Access Compliance Report

Intersection ID: 26408	Main Street: BEVINGTON_PL	Cross Street: PEMBRY_LINKS_CR	Location: SE
ADA ID: FBA685DD160B	Ramp Type: BlendTrans2	Initial Pass/Fail: Fail	Overall Compliance: No
Severity Score: 30			
Codes/Mitigation Info/Possible Solution		Field Measurements/Component Compliance

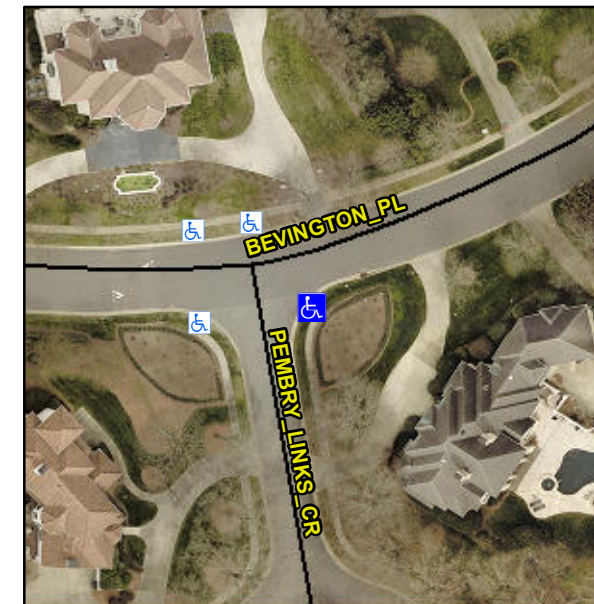
Not Found, R304.5.1, R304.5.3

Compliance	Description	Data	Compliance	Description	Data
N/A	Ramp Length (in)	120.0	Yes	BlendTrans Slope (%)	3.6
No	Ramp Width (in)	34.0	No	BlendTrans XSlope (%)	5.6
N/A	Flare Type LT	N/A	N/A	Flare Type RT	N/A
N/A	Flare Slope LT (%)	N/A	N/A	Flare Slope RT (%)	N/A
N/A	Flare Traversable LT?	N/A	N/A	Flare Traversable RT?	N/A
N/A	Landing Length (in)	N/A	N/A	DWS Provided?	N/A
N/A	Landing Width (in)	N/A	N/A	DWS Contrast?	N/A
N/A	Landing Slope (%)	N/A	N/A	DWS Length (in)	N/A
N/A	Landing X Slope (%)	N/A	N/A	DWS Full Width?	N/A
N/A	Landing Curb? (Y/N)	N/A	N/A	DWS Offset (in)	N/A
N/A	Shared Landing?	N/A			
N/A	Gutter Ponding?	N/A	N/A	Gutter Slope (%)	N/A
N/A	Gutter Lip Ht (in)	N/A	N/A	Gutter X Slope (%)	N/A
N/A	Painted X Walk1?	No	N/A	Painted X Walk2?	No
	X Walk 1 Direction	To NW		X Walk 2 Direction	To W
	X Walk 1 Width (in)	N/A		X Walk 2 Width (in)	N/A
	X Walk 1 Slope (%)	6.8		X Walk 2 Slope (%)	1.5
	X Walk 1 X Slope (%)	3.1		X Walk 2 X Slope (%)	4.0

N/A	Ramp inside XWalk1?	N/A	N/A	Ramp inside XWalk2?	N/A
	Road Slope (%)	6.0		Clear Space?	N/A
	Road X Slope (%)	1.0	N/A	Clear Space to XWalk (in)	N/A
N/A	Any Obstructions?	N/A	N/A	Storm Grate/Utility Hazard?	N/A
	Obstruction Type			Storm Grate/Utility Type	
		N/A			N/A
			Yes	Surface Condition? (G/P)	Good
			No	Curb Slope (%)	12.4

Remove & Replace Curb Ramp With Two New Directional Ramps or Equivalent.
